# OPEN MEETING COVER SHEET COMMISSIONER MEMORANDUM

**CAPTION:** Docket No. 57579; SOAH Docket No. 473-25-11558 – Application of CenterPoint Energy Houston Electric, LLC for Approval of its 2026-2028 Transmission and Distribution System Resiliency Plan

RE: August 21, 2025 Open Meeting – Agenda Item No. 24  
Docket No. 57579 – *Application of CenterPoint Energy Houston Electric, LLC for Approval of Its 2026-2028 Transmission and Distribution System Resiliency Plan*

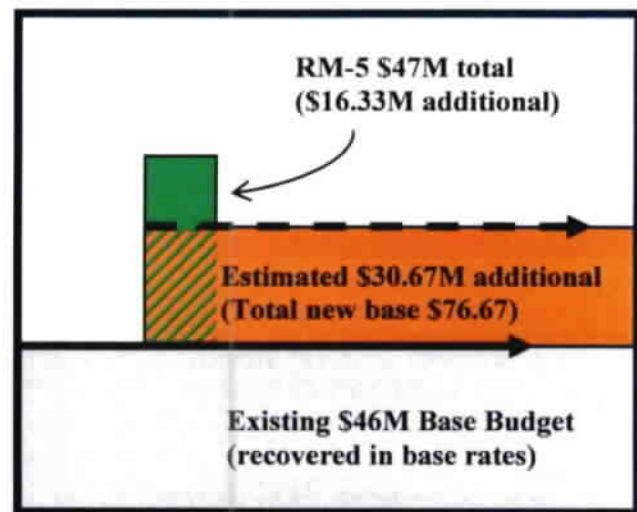
CenterPoint's current base vegetation management budget is \$46 million annually, based on a five-year trimming cycle, represented in gray in the accompanying graphic. Through RM-5, CenterPoint requests \$47 million annually (\$141 million total) to move to a three-year trimming cycle, represented in green. And, in the absence of a response from CenterPoint, I calculated an annual budget on a three-year cycle at their current spending levels would be about \$76.67 million (\$30.67 million additional to the current base budget), represented in orange. This shows roughly \$16.33 million each year (\$46 million base plus \$47 million extra requested, less the \$76.67 million new base) that CenterPoint can clearly attribute to the cost of transitioning to a three-year cycle and not to the baseline cost of meeting its obligation to customers to perform vegetation management.

To be clear, I am supportive of RM-5, but consumers deserve transparency between increased base budgeting and the unique investments made through these resiliency plans. In their stipulation and settlement agreement, CenterPoint included terms that would

authorize the company to recover vegetation management costs above \$46 million in a regulatory asset authorized under PURA § 38.078(k). Based on my concerns and estimates above, I recommend we change that threshold to \$76.67 million, which better distinguishes the ongoing obligation CenterPoint intends to fulfill towards its customers from the cost to transition to a three-year cycle, which I believe is an appropriate investment as part of this plan.

FOF. It is appropriate to limit the amount recoverable for the Vegetation Management measure (RM-5) through a regulatory asset under PURA § 38.078(k) to amounts above \$76.67 million per year.
